**SHIQAQ HAI MUSALLA
PRIMARY HEALTHCARE CENTER
KIRKUK, IRAQ**

SUSTAINMENT ASSESSMENT

**SIGIR PA-08-157
APRIL 13, 2009**

SUBJECT: Report on the Shiqaq Hai Musalla Primary Healthcare Center, Kirkuk, Iraq
(SIGIR Report Number PA-08-157)

Site Photo 4. Two generators providing primary and emergency backup power for the PHC

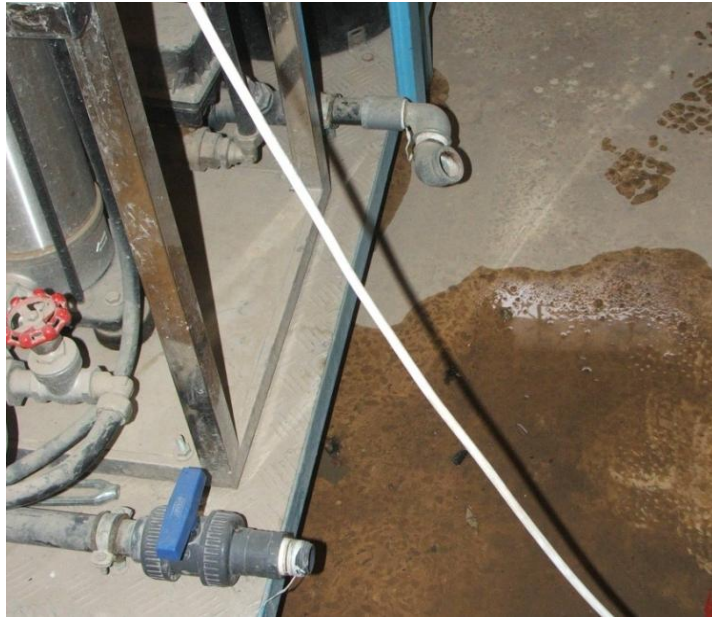
SIGIR noticed no visible evidence of fuel leaks in the fuel line or inside the generator housing. The fuel line appeared to be galvanized steel pipe that was placed on the surface of the ground (Site Photo 4). Galvanized steel is susceptible to corrosion and may over a long period of time create issues with fuel leaks. Without careful monitoring, small leaks may go undetected, potentially wasting fuel, increasing the risk of fire, harming the environment, and endangering the welfare of the occupants.

Site Photo 8. Dental chair and tools

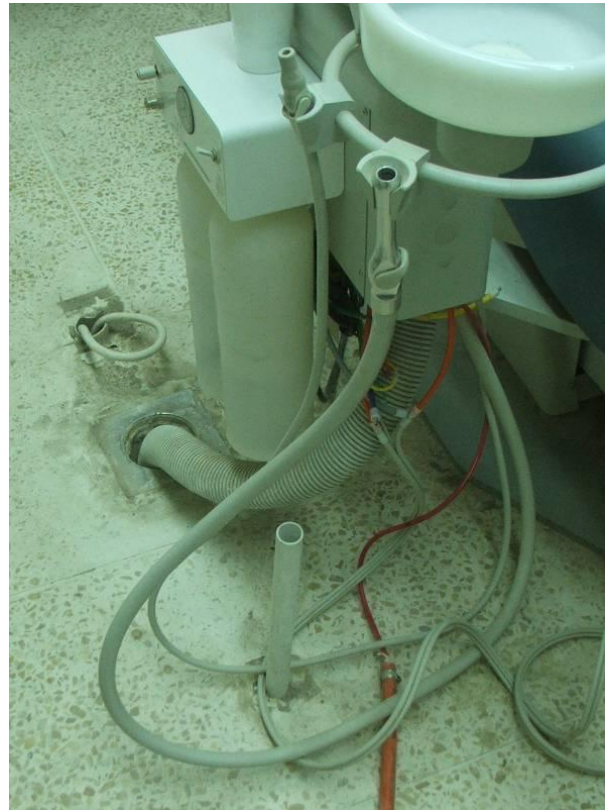
During the site visit, SIGIR observed that the dental chairs were installed and appeared to be in use (Site Photo 8). During the inspection, SIGIR observed a dentist treating a patient while using the dental chair.

The contractor's installation of the dental chairs, while functional, did not appear to conform to any known plumbing or electric code. The drain for the chairs was placed directly into the floor drain with a significant gap between the floor drainpipe and the chair discharge hose. The electrical connection for the chair was made using a modified extension cord (Site Photo 9).
